Location Address: 5701 Pembroke Rd Hollywood, FL 33023

SUBJECT: Preliminary Site Plan review for a building of approximately 5,250 square feet.

City of Hollywood
Division of Planning and Urban Design
Technical Advisory Committee
2600 Hollywood Boulevard, Room 315
Hollywood, FL 33022-9045

SEDIMENT & EROSION CONTROL PLAN

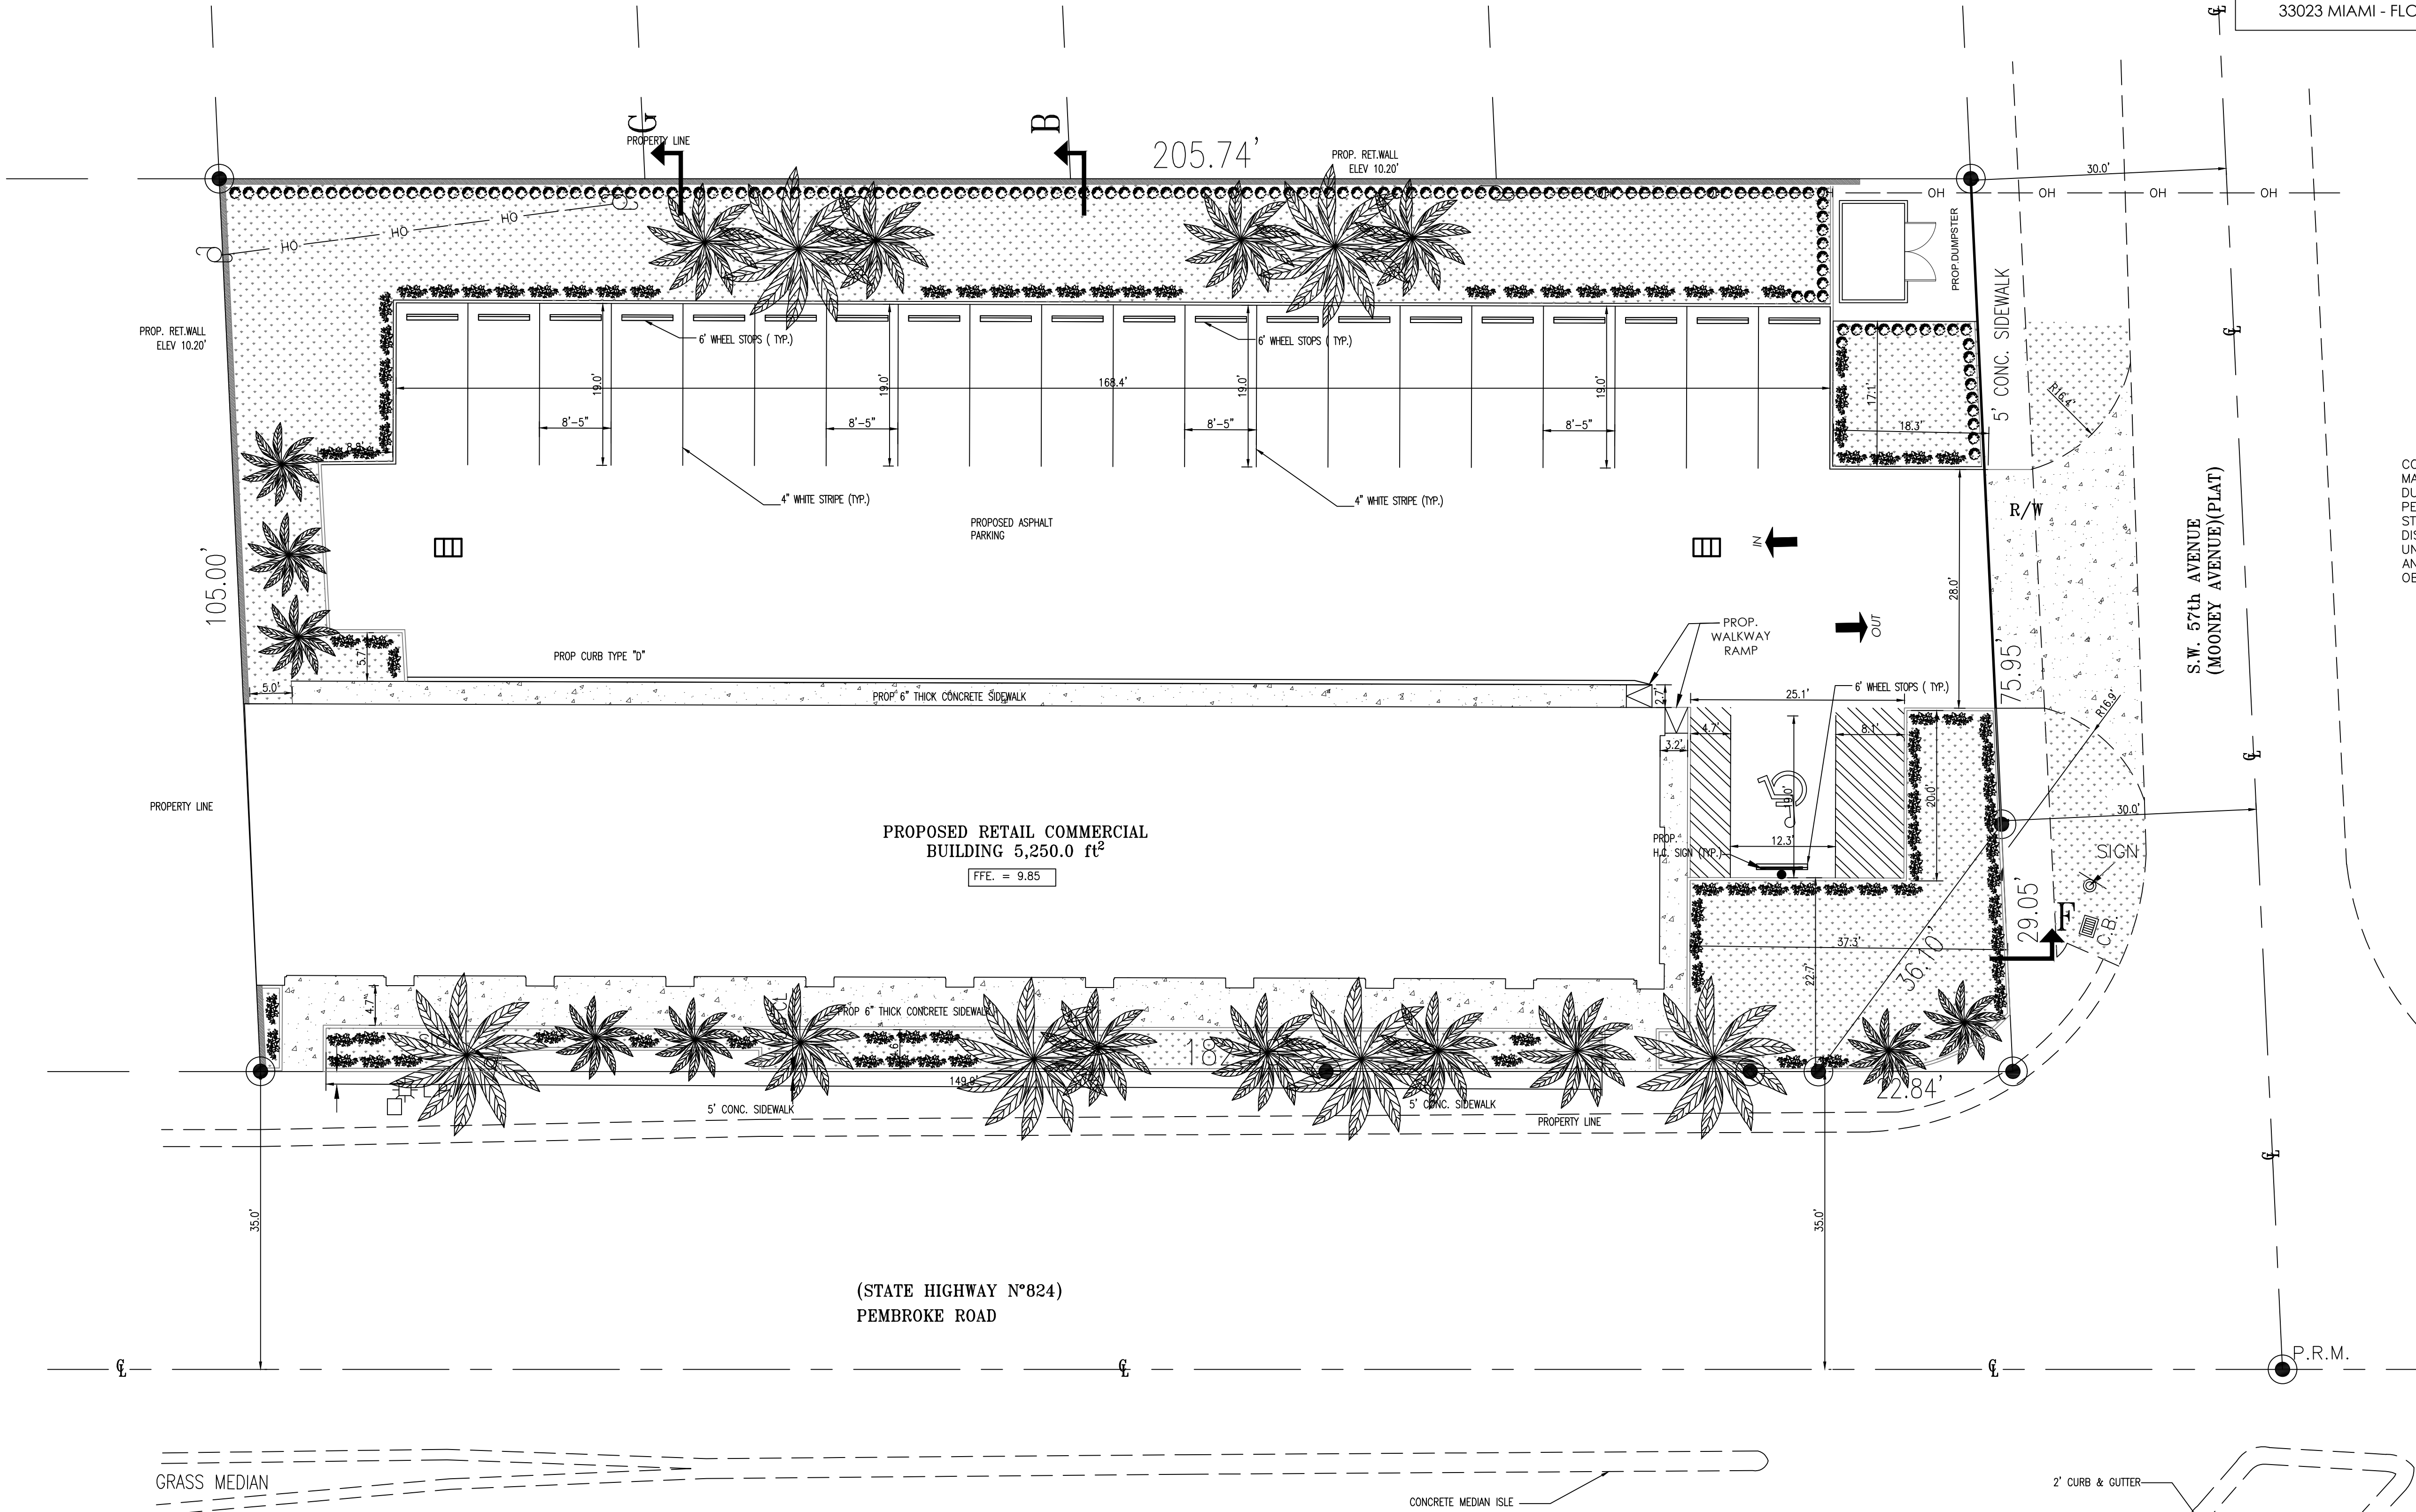
10. Erosion and Sediment Control plan must be updated with silt fence around property perimeter to prevent sediment flow across property lines. Silt fence detail shall be provided showing filter fabric stretched across and attached to supporting posts and entrenched. Plan shall also show temporary gravel construction entrance, and other Best Management Practices to mitigate environmental hazards caused by proposed construction.
Acknowledged, please refer to C-6.0.

SHEET NUMBER:
IR-02

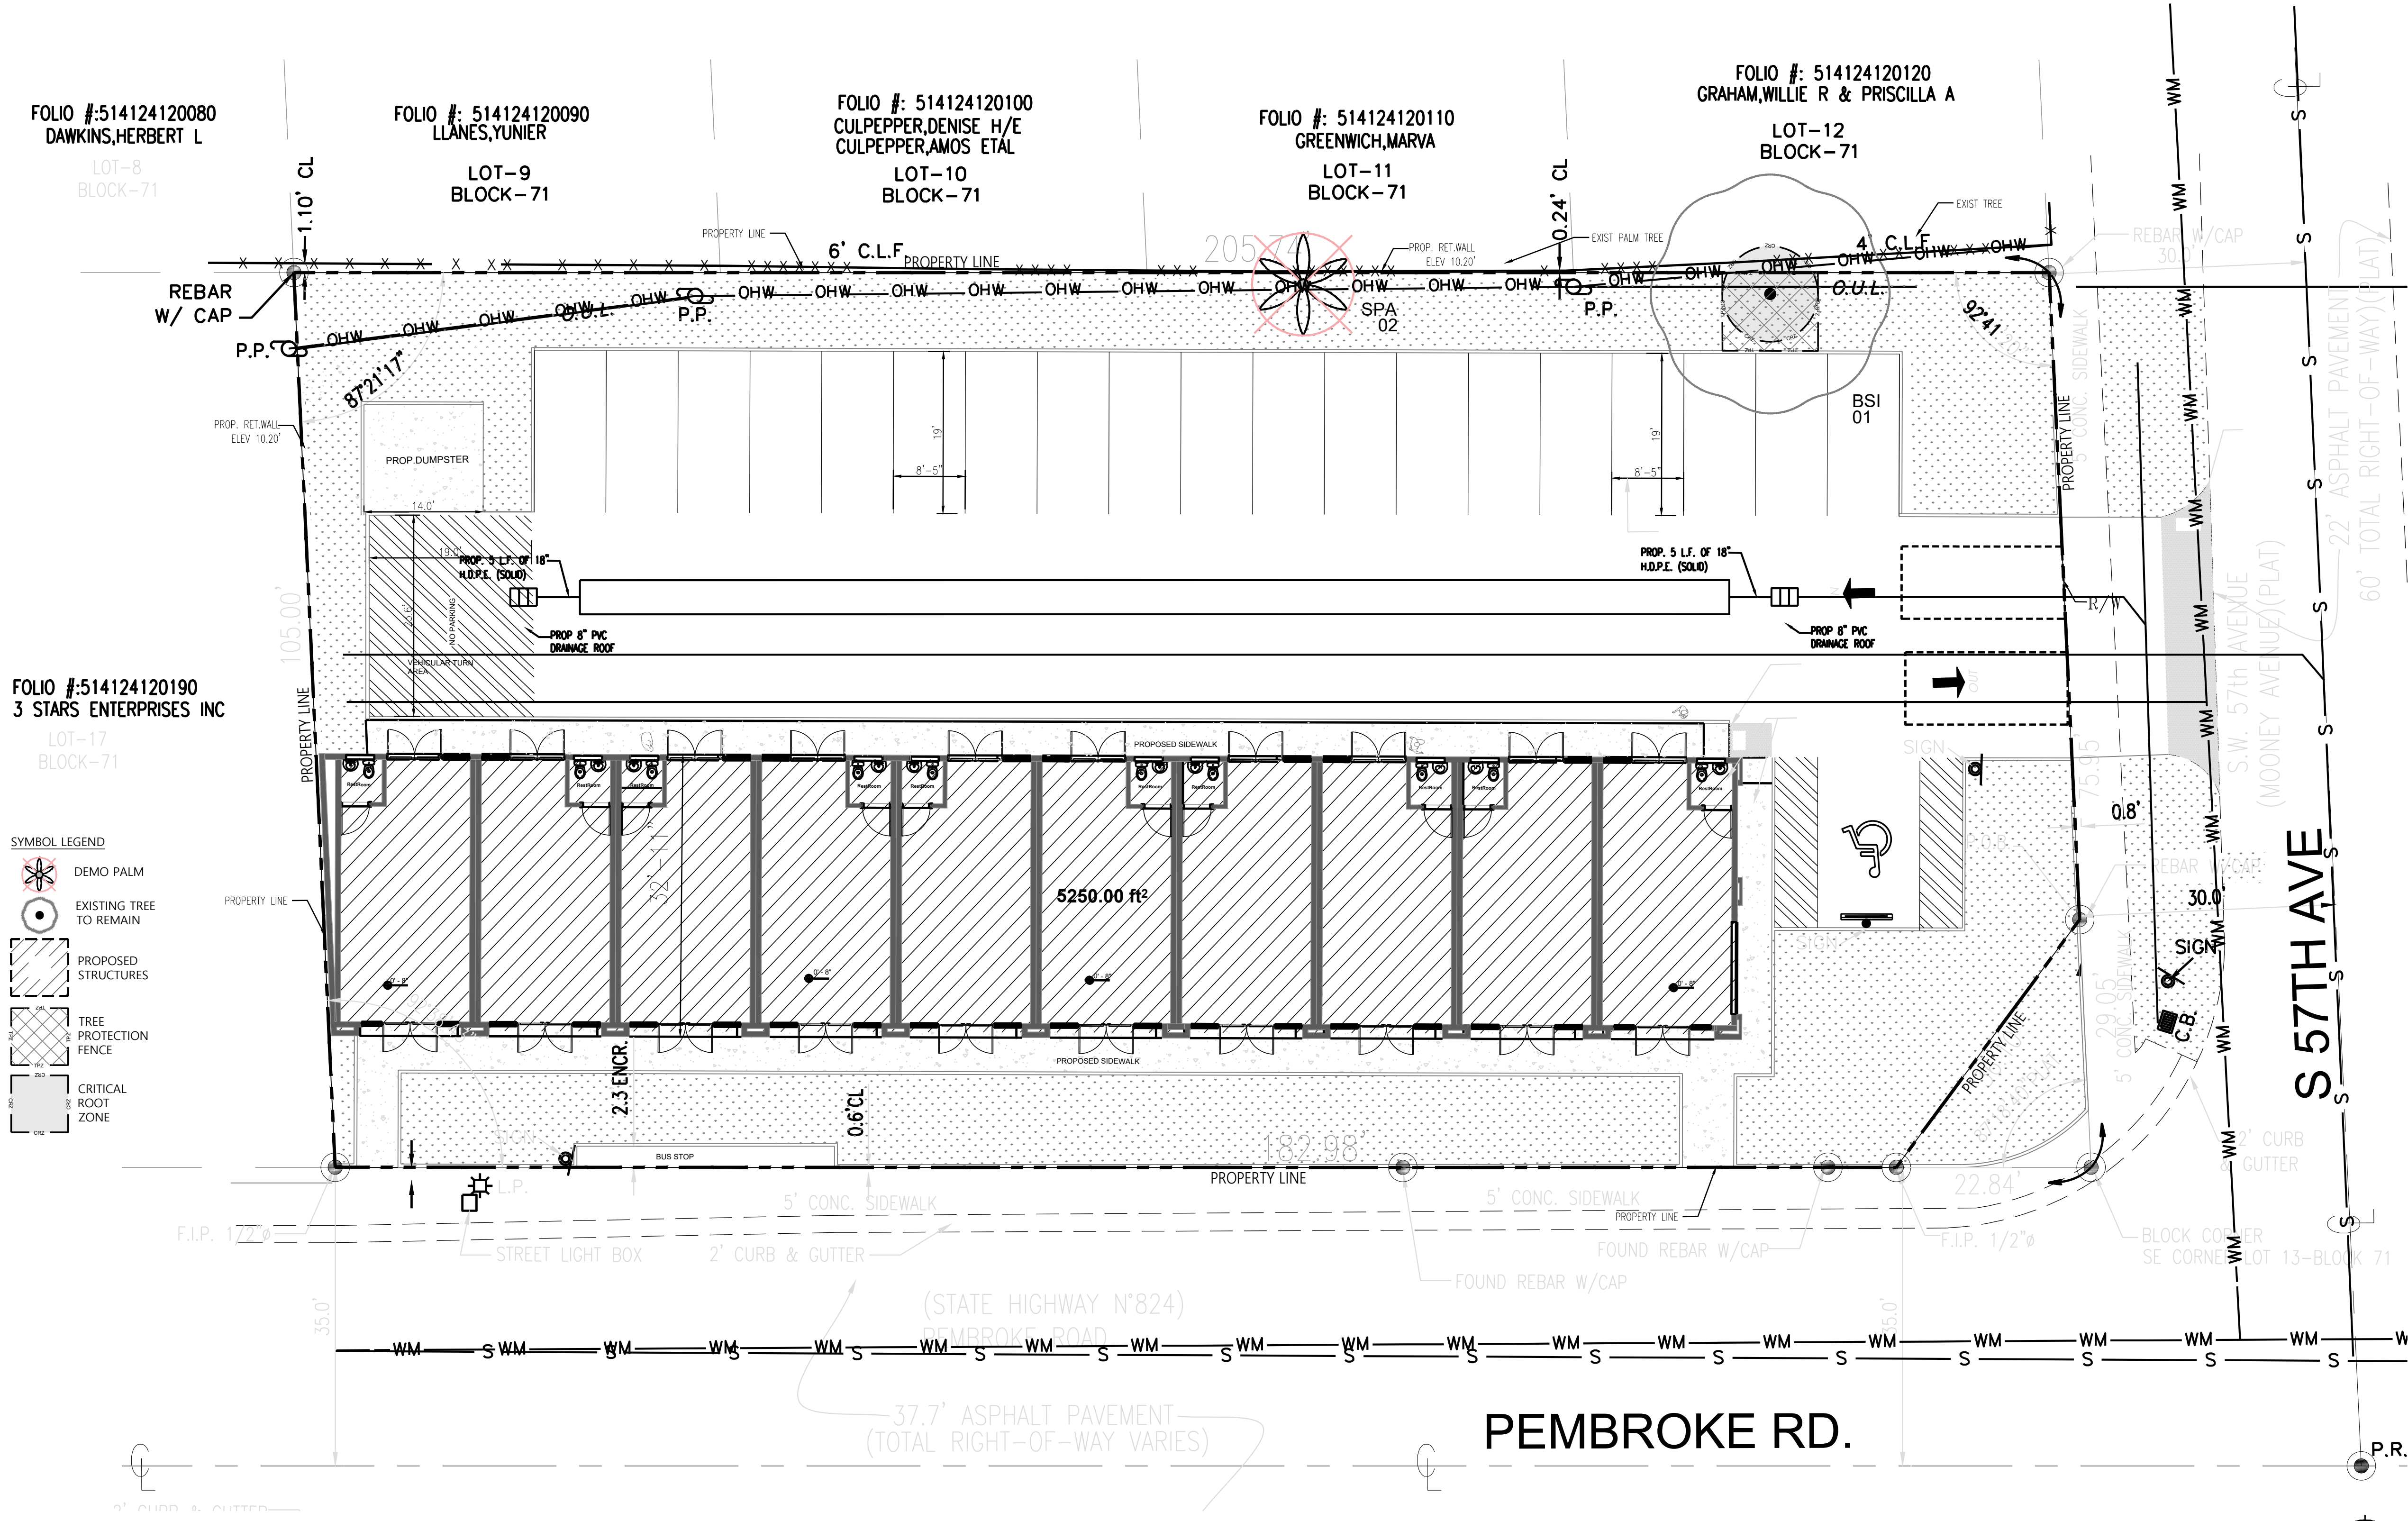
1. See pages L-02 and L-03.
11. Add note: 100% irrigation coverage shall be provided. DONE
1. See page IR-02, in Landscape and Irrigation Note box.
12. All driveway access shall have visibility triangles at the intersection of the property line and the driveway. Please show on plans all visibility triangles at all driveway accesses. A visibility triangle is an area adjacent to a driveway and the private property line where the driveway intersects a street/alley. If the property line is less than 12 feet from the edge of pavement in the rights-of-way, provide a 12'X12' visibility triangle along the property line and driveway within the private property. If the distance is greater than 12 feet provide a 12' (along driveway on private property) X 6' (along property line) visibility triangle. All fences, walls, bushes, hedges, and any other landscaping or plant material, within the view triangle shall provide unobstructed cross visibility at a level between 30 inches and 72 inches above ground level. Please address in plans. DONE
